RE: **Grants Reclamation Project – DP-200 Renewal – Response to September 12, 2000 NMED Letter Transmitting Comments / Questions on Renewal Application**

**HOMESTAKE MINING COMPANY
Grants Reclamation Project
DP-200 Renewal**

**RESPONSES TO
NEW MEXICO ENVIRONMENT DEPARTMENT
REGARDING QUESTIONS / COMMENTS ON DP-200
RENEWAL APPLICATION
PER
NMED LETTER DATED SEPTEMBER 12, 2000**

FIGURE 45. NITRATE CONCENTRATIONS FOR WELLS D1, X, S4, F, FB AND GH.

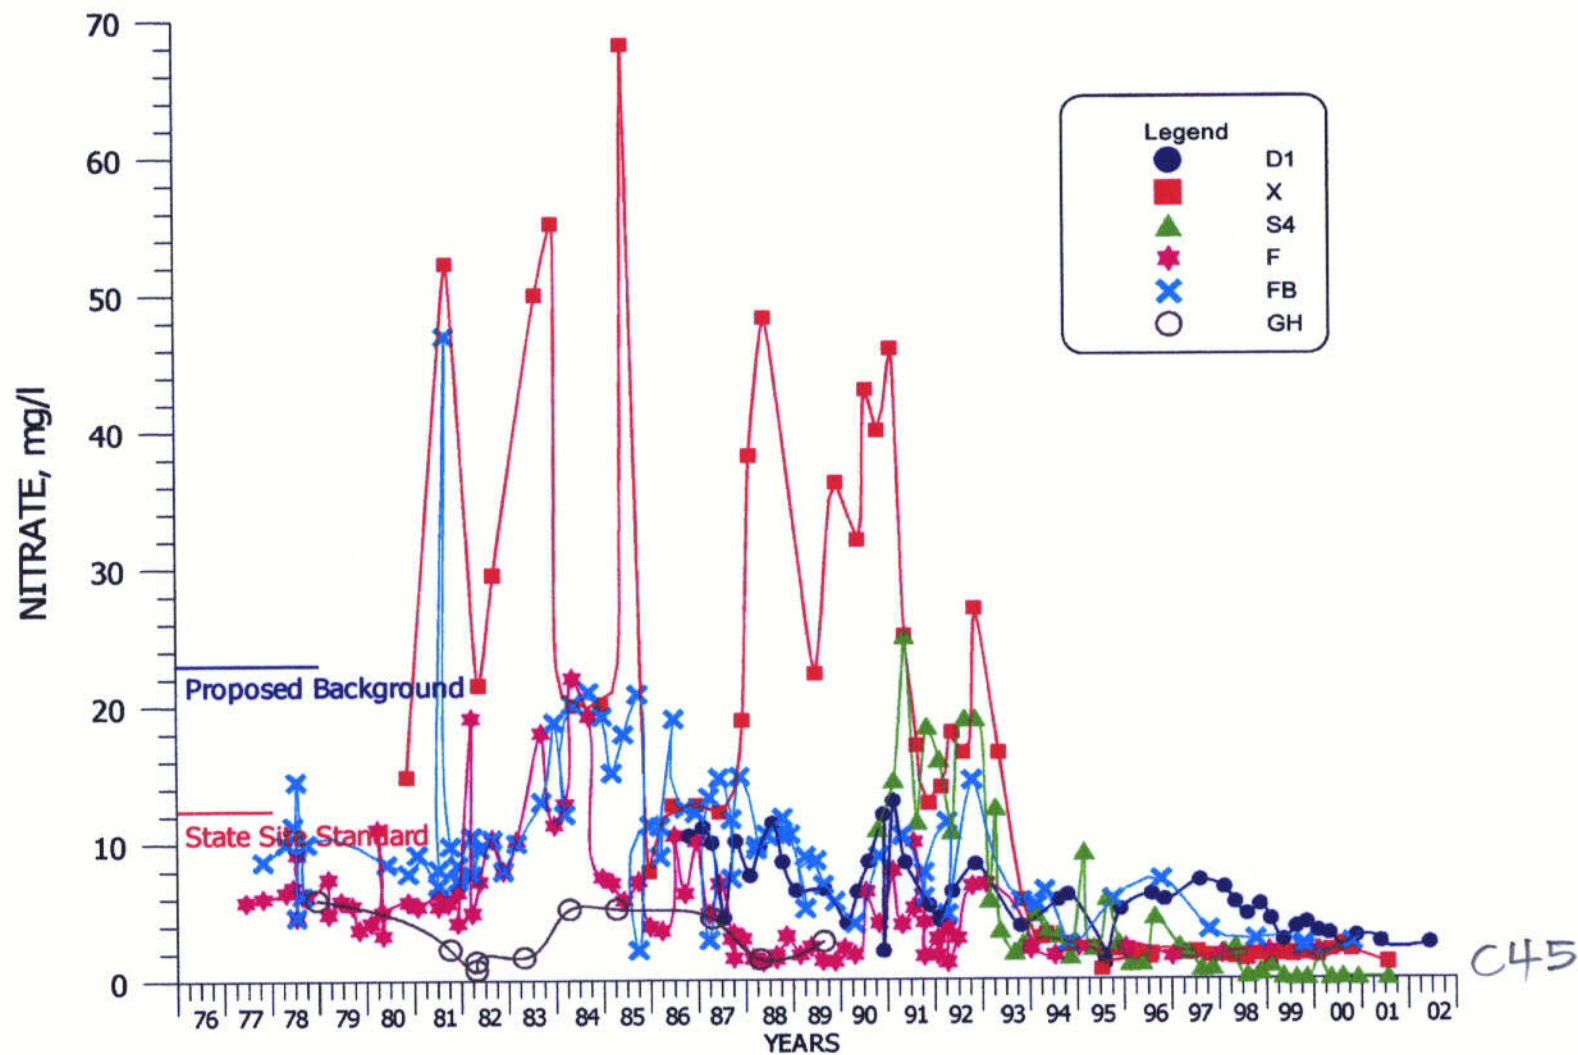
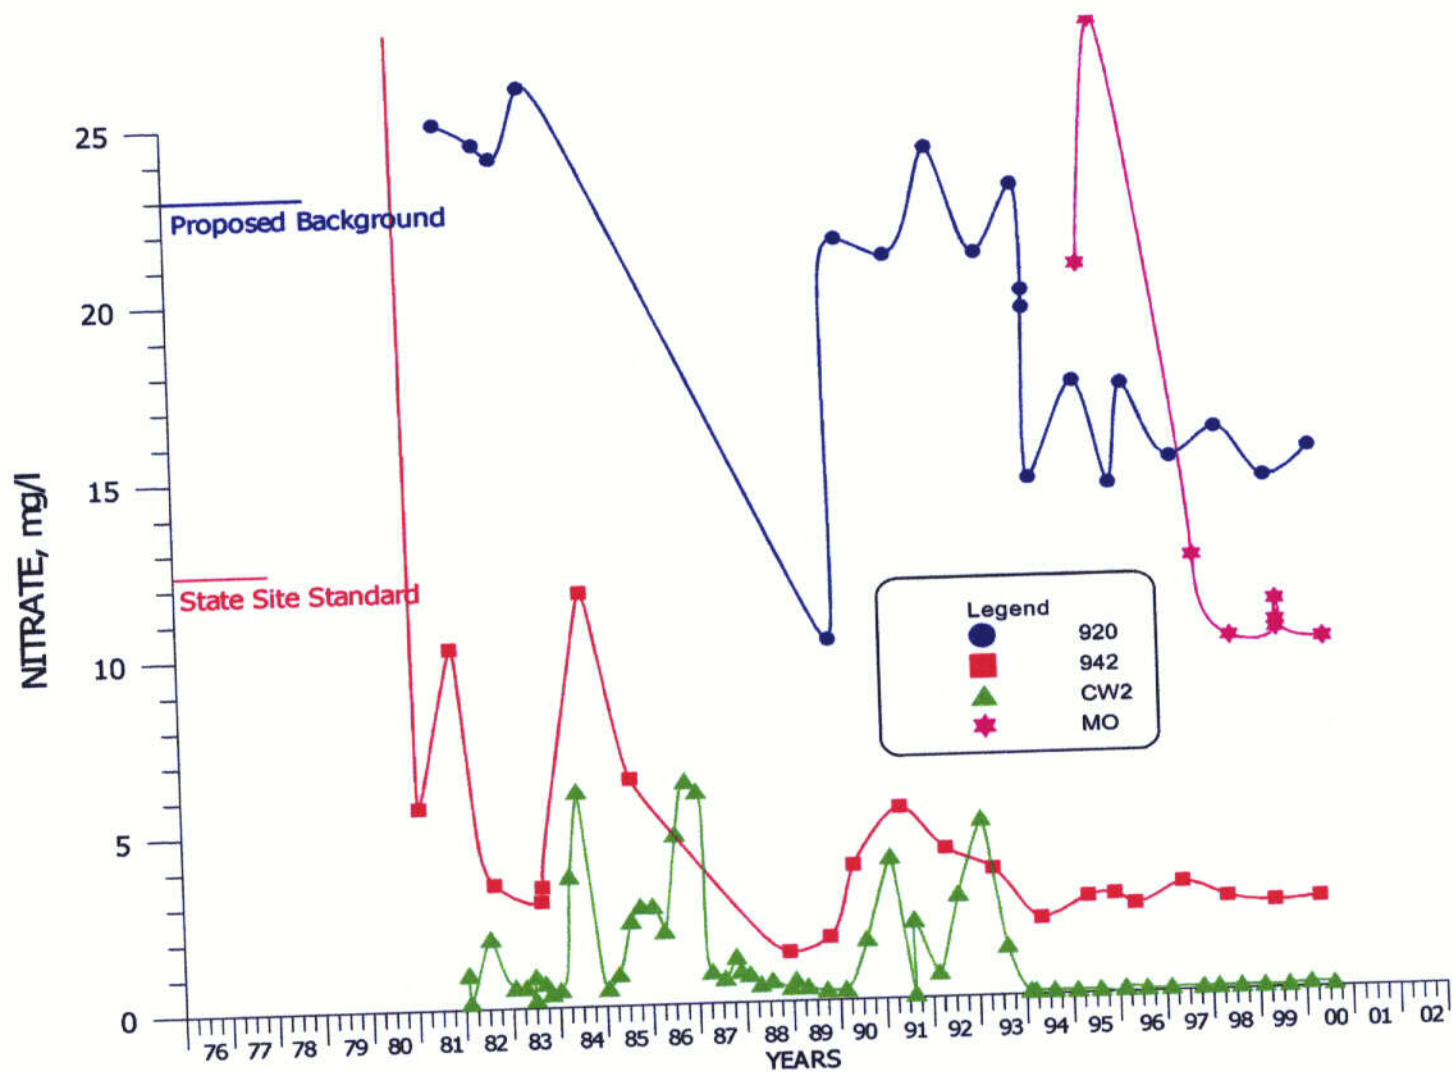
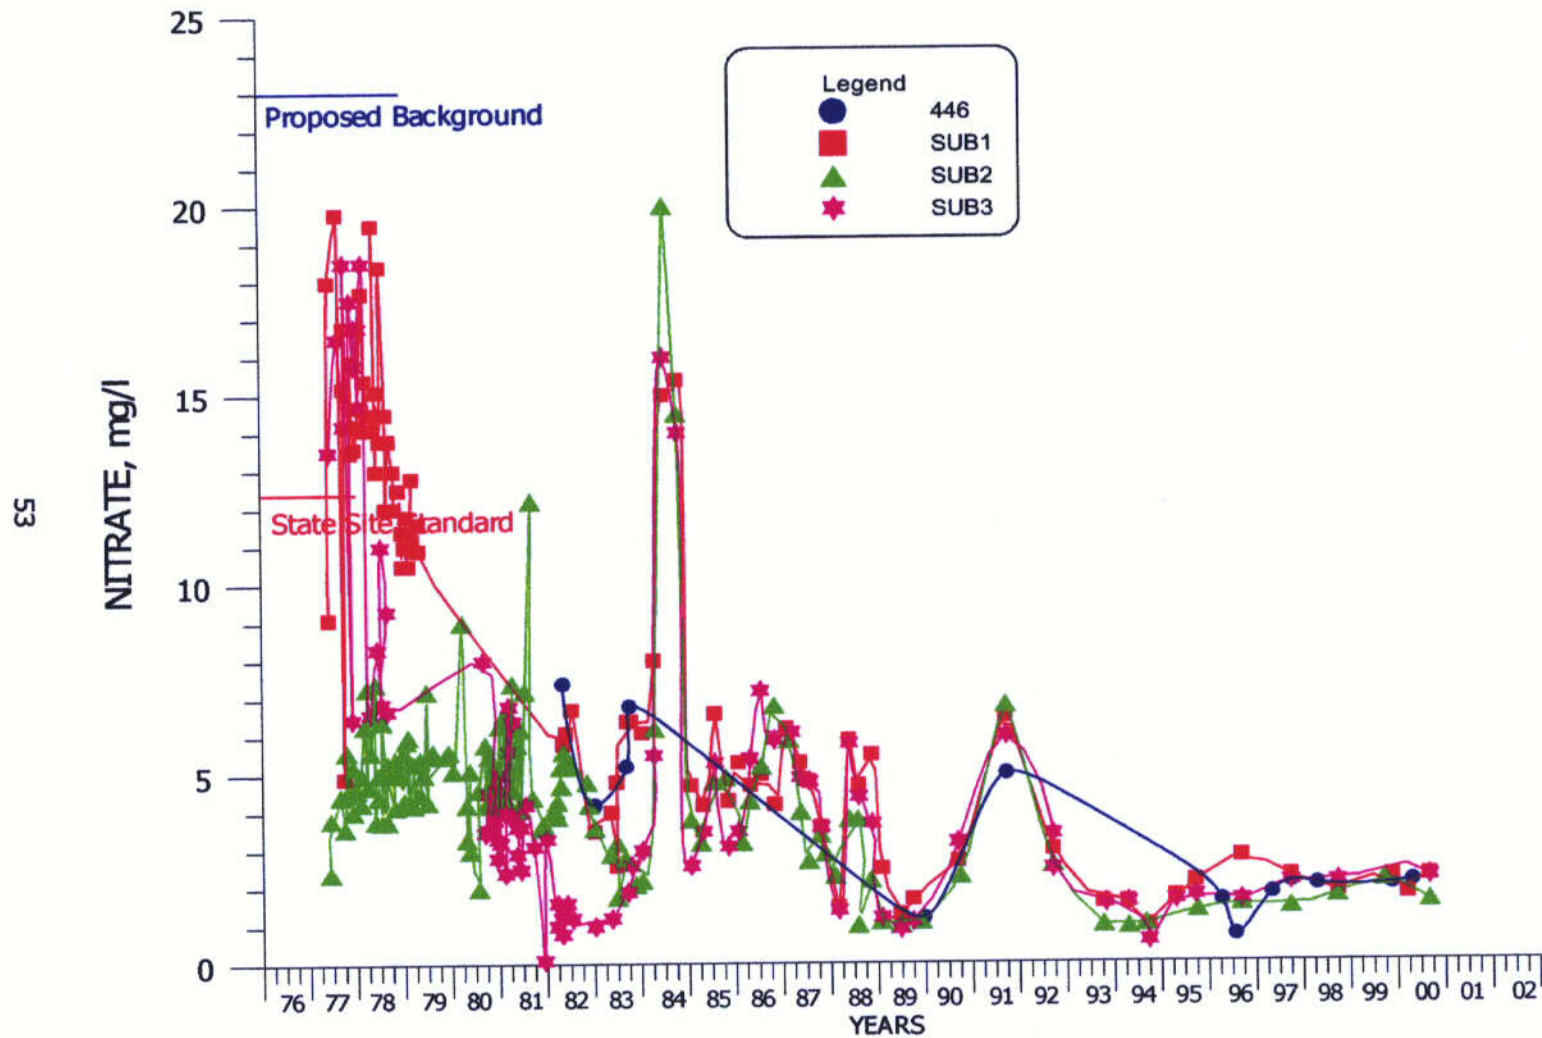
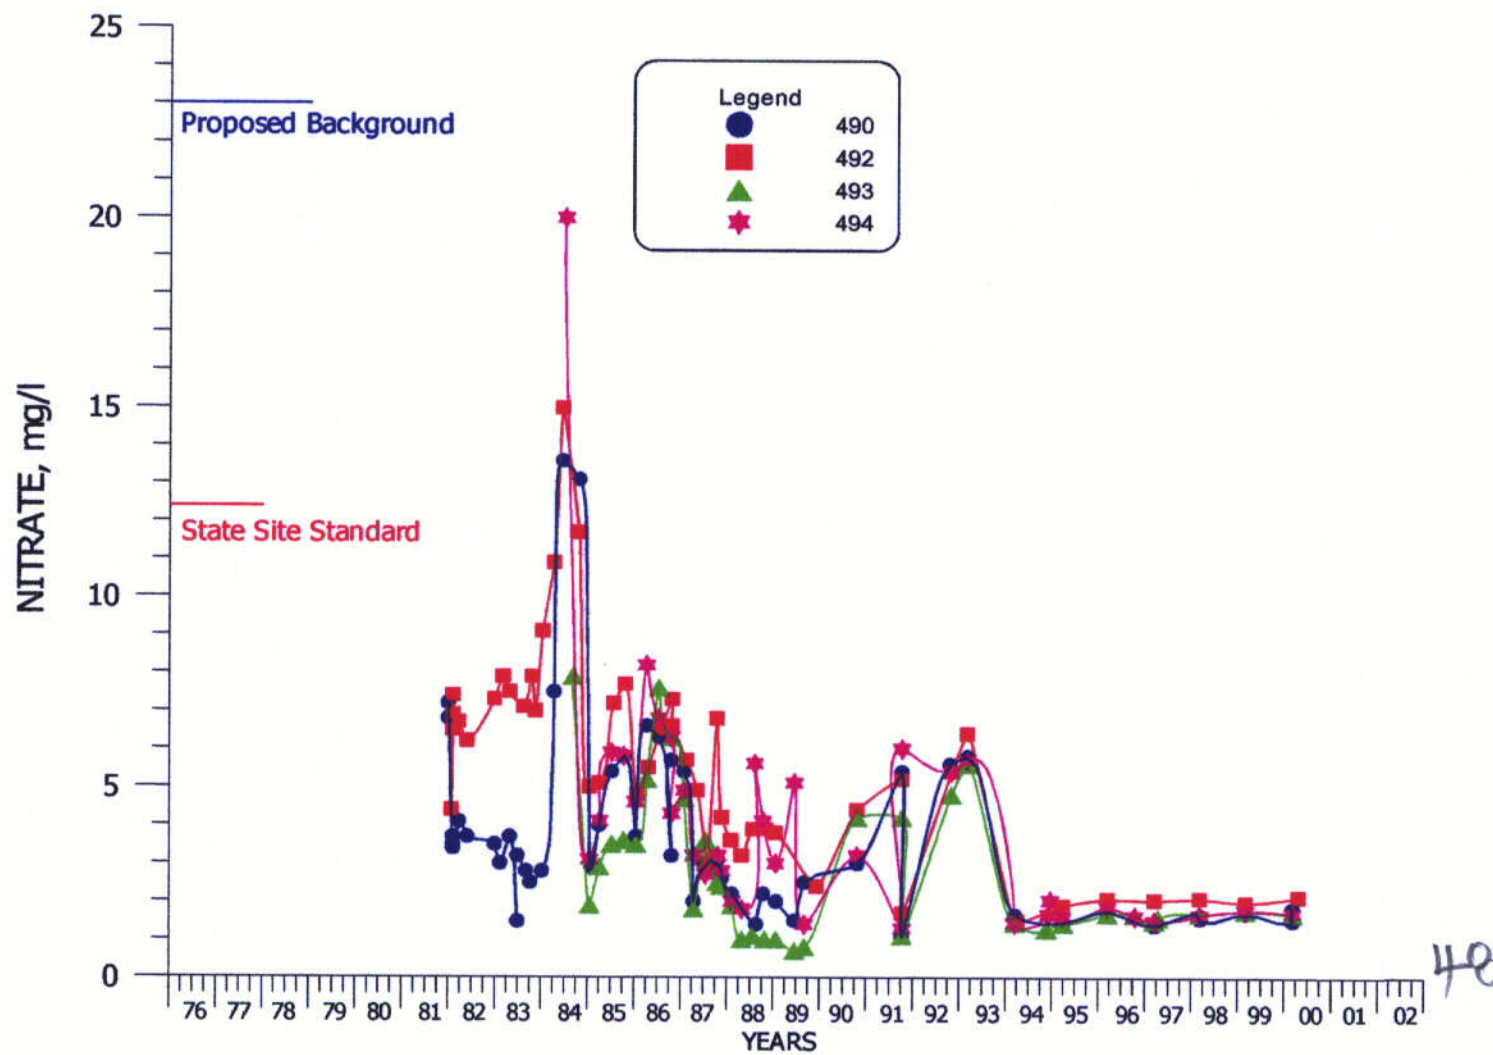
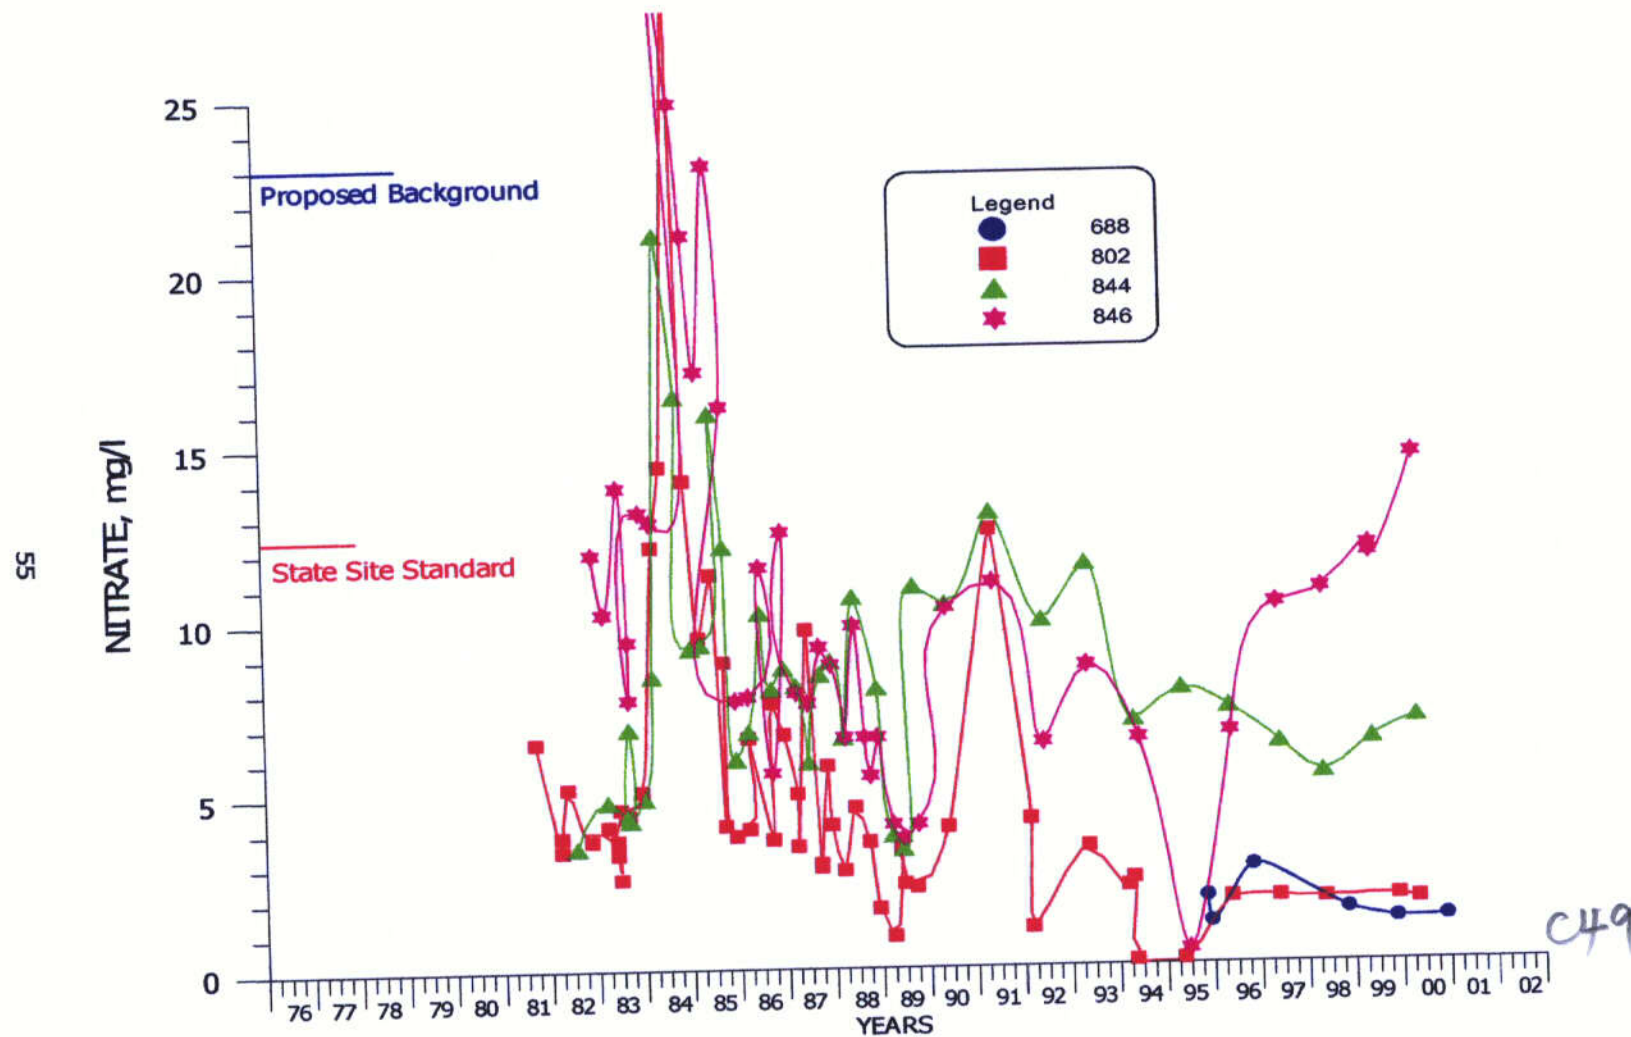
Comment: III.1.B. Graphs of Water-quality Data for the Table 2 Wells

Response: Plots for the routine monitoring wells from Table 2 of the NRC license are presented for sulfate, TDS, chloride, uranium, selenium, molybdenum and nitrate concentrations as Figures 15 through 49. The first group of wells for each of these constituents are presented for the three POC wells (Wells D1, X and S4) and

the initial figure also includes on site wells (Wells F, FB and GH). The following tabulation lists the figure numbers for each of the constituents:

CONSTITUENT	FIGURE NUMBER
SO4	15 – 19
TDS	20 – 24
Cl	25 – 29
U	30 – 34
Se	35 – 39
Mo	40 – 44
NO3	45 – 49

A few different vertical scales were required due to the large variations in parameter concentrations. The present State standard and the proposed background concentrations are presented on the plots.
